Modifications for a Shallower Pit Relevant to pits Type 1-8 & 53

Bulletin No.: TB201305
Date: 21 March 2013
Issued By: CC

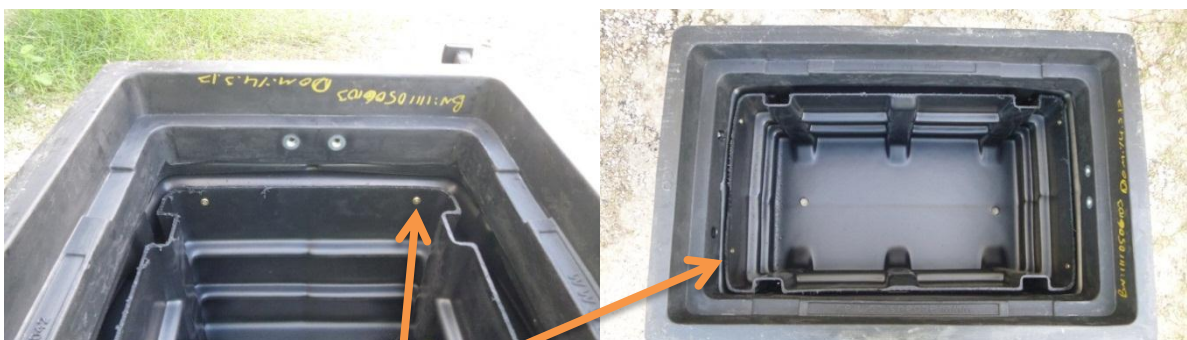
1. Cut the base of the pit below the step at the cutting line.

2. Flip the top section upside down and trace the base profile onto the bottom of the top section. Enlarge the hole with a jig saw. This will allow the base section to slide inside the top section. The marking can be done before cutting if desired.
